pd-trigger — Design Document

ai-ee v1 pipeline

Board review (P8 adversarial) - pd-trigger

Sheet: /
File: pd-trigger.kicad_sch
Title: pd-trigger: USB-C PD sink trigger, 5 A pass-through
Size: A3 | Date: 2026-07-28 | Rev: 1
R/Cas E.D.A. 10.0.3 | Id: 1/1

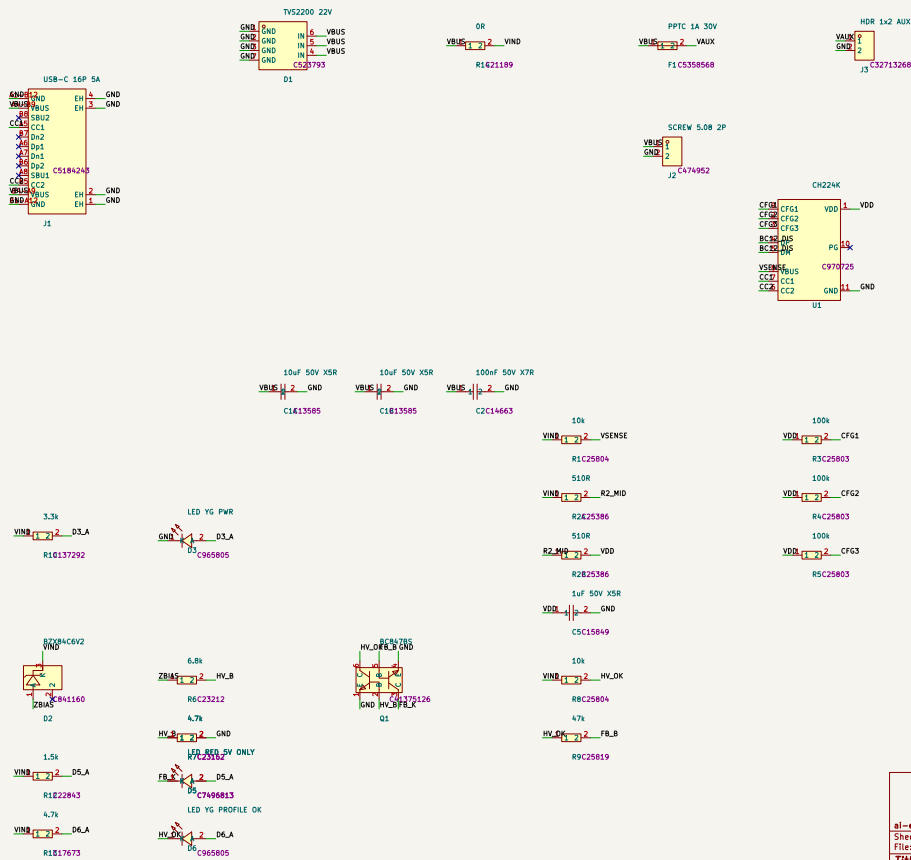
W1 dp-dm-short-at-chip: architecture's PD-only short (/BC12.DIS) ACCEPTED by the reviewer as hardware-SAFER than the datasheet's connector wiring (removes a 21V-onto-3.8V-abs-max fault path). Cost: no QC/BC legacy support - the board is "PD sources only"; goes on B.SilkS + order docs. W2 vdd-worst-corner: true worst case 0.979mA at 4.4V low-line all-straps- closed vs unpublished CH224K IDD - bounded by WCH's own reference circuit; V1 bring-up step: measure VDD at the 5V profile; contingency = both 510R -> smaller (documented floor 600R total). Bring-up addenda: buzz out Q1 E/B/C once (clone PDF JS-gated; Nexperia- standard pinning verified as the compatibility claim).

reports/render_final/top.png

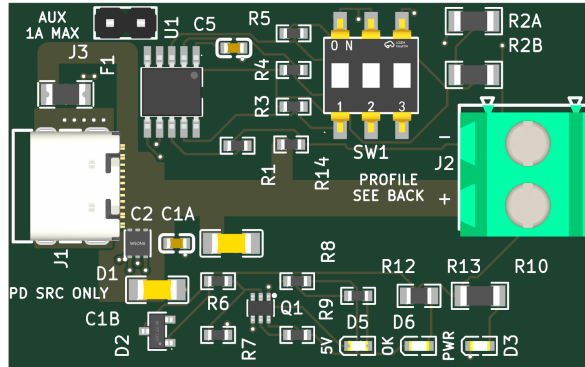
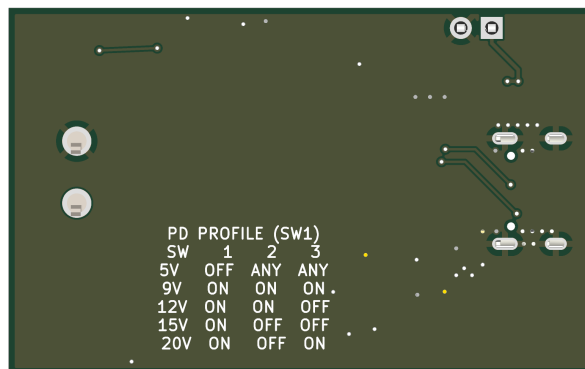
E1 - 5 A return chokes at J1's GND contact pads (error, checker-blind by design D7)

The 4 GND cable contacts land on two merged SMD pads (F.Cu only): A1-B12 at (17.63,39.31) and B1-A12 at (17.63,45.71), nominally 2.5 A each at the 5 A rating. Their ONLY copper into the B.Cu return pour:

- A1-B12 (top): a 0.2 mm wide, 2.7 mm long F.Cu chain (3 segments) into shell pad 1's THT barrel, plus one 0.6/0.3 via whose annulus grazes the pad corner by ~0.05 mm (etch-tolerance-level). 0.2 mm at 2 oz = 0.80 A capacity at 10 C rise (pipeline model); at 2.5 A the same model gives ~133 C rise (short-neck heatsinking will moderate this, but it is a >3x overcurrent on the model's own terms). ~13.6 squares = 3.3 mohm.
- B1-A12 (bottom): a 0.2 mm x 1.3 mm trace into ONE 0.6/0.3 via. The board's own via budget (constraints via_amps 0.5) says 2.5 A needs 5 vias; there is 1. Shell pad 4 sits 0.32 mm away but is NOT connected on F.Cu - its copper does not help.

Architecture D7/power_tree structural requirement ">= 10 vias at J1's GND pads" (the stated substitute for keeping GND out of power[] so check_current stays quiet): not delivered. DRC cannot see it (0.2 mm is netclass-legal), check_current cannot see it (GND undeclared), check_return_path no-ops (no high_speed key). Failure mode: sustained 5 A at any profile heats the two necks far past the 10 C design intent; long-term trace/joint fatigue, intermittent ground, and full return current cascading onto the surviving 0.2 mm chain. Fix is cheap at P9: an F.Cu GND spandrel bonding each contact pad to its shell pad (the VBUS pour top edge is at y 39.7 - the strip above it, and the strip x < 17.2 plus the region south of y 46, are free) plus 4-5 vias per side.

E2 - Safety/waiver silk markings absent (error, promised artifact) Board-wide gr.text count is ZERO; B.SilkS carries nothing at all (both B.SilkS references in the file are the stackup layer table). Missing, each one a written promise:

- AUX 1A MAX + V+/GND at J3 (P0 answer 4 "silk-marked", V10). F1 makes overload safe-by-hardware, but polarity of the 2-pin aux header is unmarked.
- PD SOURCES ONLY (ERC waiver W1's standing condition: "goes on B.SilkS + order docs"). The waiver's silk half is currently unfulfilled.
- J2 screw-terminal polarity. Trunk lands on J2 pad 1 = the LOWER screw (board-bottom side); nothing anywhere tells the bench user which screw is V+. Reverse-wiring a load on a 100 W output is the single easiest field mistake this board can cause.

E3 - User-interface silk absent (error, promised artifact)

- The five-row profile table on B.SilkS - D3 calls silk "the user interface" and specifies the table verbatim; the bottom is a clean pour with room. Without it the ON/OFF-to-voltage map exists only off-board; a user WILL set 9 V expecting 12 V by trial and error. (Fail-safe floor: any wrong guess >= the 5 V fallback, and OFF-fail = 5 V - the mistake is bounded but real.)

- LED legends PWR / 5V ONLY / PROFILE OK (D4/V10): the render shows refdes D3/D5/D6 only. The entire P0-answer-6 "visible fallback indication" scheme is mute without the words - a lit red LED labeled "D5" indicates nothing.

- Cable disclaimer "20V @ 5A needs a 5A e-marked cable and a 100W source" (V10 lists it as silk; power_tree s7 allows documentation - at minimum it must reach the order docs at P9/P10, which do not exist yet; fab/ is empty).

- PRESENT and correct: SW1's own footprint prints ON + 1 2 3 (the compact F.SilkS marker D3 asked for) - confirmed on the top render.

W1 - J1 mouth recessed ~0.4-0.5 mm behind the board edge (warning, flagged at P6)
Courtyard/silk front edge $x = 10.18$ vs board edge $x = 9.8$. USB-C receptacles are normally flush-to-overhanging; a recessed mouth lets thick/molded plug overmolds butt the board edge and hold the plug fractionally short of latch - intermittent CC, no PD, "works with some cables". On a bare bench board with arbitrary cables this is a real annoyance risk. Fix: nudge J1 -x 0.5-1.0 mm at P9 (pour edge follows; nothing else in that corridor), or accept and note in order docs.

W2 - Outline 48 x 30 mm exceeds the architecture's hard ceiling (warning, drift)
Edge.Cuts = (9.8,27.51)-(57.8,57.51) = 48 x 30 mm. D9: nominal 45 x 25, "hard ceiling 48 x 28 mm"; 30 mm violates D9's own ceiling by 2 mm even though it equals P0 answer 5's literal +20 % (40x25 -> 48x30, +44 % area vs the brief's target). No digest discloses the growth past D9. Consequence is cost/footprint only, but it must be disclosed to the user at the checkpoint rather than discovered.

A1 - J2 GND pad ties to the return pour through 4 thermal spokes (advisory) J2 pad 2 (THT, 2.4 mm pad / 1.6 mm drill) connects via 4 x 0.5 mm diagonal spokes = 2.0 mm total at 2 oz -> model 8 C rise at 5 A. Legal and functional, but these are the most-loaded copper necks on the whole return after E1, at a hand-soldered joint. Recommend a solid-connect override (or a short fat GND strap) at P9; zero cost. (Verified all 4 spokes present; the VBUS pad 1 island below it is barrel-tied, normal.)

A2 - F1's VBUS feed branch is 18.3 mm long (advisory, V8 letter-violation) V8/D8 wanted all five VBUS taps hugging the run with 2-3 mm stubs. D1, C1A, C1B, C2, R14 comply; F1's feed runs 8.4 + 6.5 + 3.4 mm at 1.75 mm width to the top-left corner. Width-compliant (V8's actual purpose), carries ≤ 1 A in service; only cost is ~30 mm² of extra always-live 20 V copper. No action needed; recorded as drift.

A3 - Floating 0.65 mm² GND sliver at (20.0, 28.5) (advisory, cleanup) plane_repair's own dead-island fact (0 anchors), between J3/SW1 clearances. Cosmetic / minor DFM nit; remove at P9 cleanup or accept.

A4 - /VAUX at PPTC max-non-trip current (advisory) /VAUX routes at 0.3 mm (required 0.25 at the declared 1.0 A -> 7 C). F1's worst sustained NON-trip current is ~1.8 A -> model 27 C rise on those runs until/unless the PPTC trips. Bounded, no damage threshold approached (70-80 C copper on a 20 V node); acceptable. Recorded so nobody "fixes" it blind later.

```
# P8 digest (pd-trigger)
verify PASS 8/8 first try. Fable reviewer: 4 err + 2 warn. Copper errors
REAL: 5A RETURN choked at J1 GND pads (0.2mm necks/0.80A, 1 via) - rebuilt
w/ priority-1 F.Cu GND lobes (connect.pads solid) + 15 new 0.6/0.3 vias ->
5.68A/4.70A per pad, 16 vias (D7 >=10 met). Removed 2 stitch vias 0.121mm
from THT drills - LIVE-PROVEN KiCad DRC blind spot (via-drill vs same-net
pad-drill never checked, finding 34). Silk errors: 17 texts added; agent
CORRECTED the orchestrator's B-table spec (raw CFG bits would be inverted
vs ON=GND switch reality - printed switch positions). Warns: mouth recess
-> order docs; outline 48x30 deviation recorded; C1B channels waived w/
numbers. Re-gates: drc_routed 0/0, verify 8/8. H4 AUTO-approved.
```
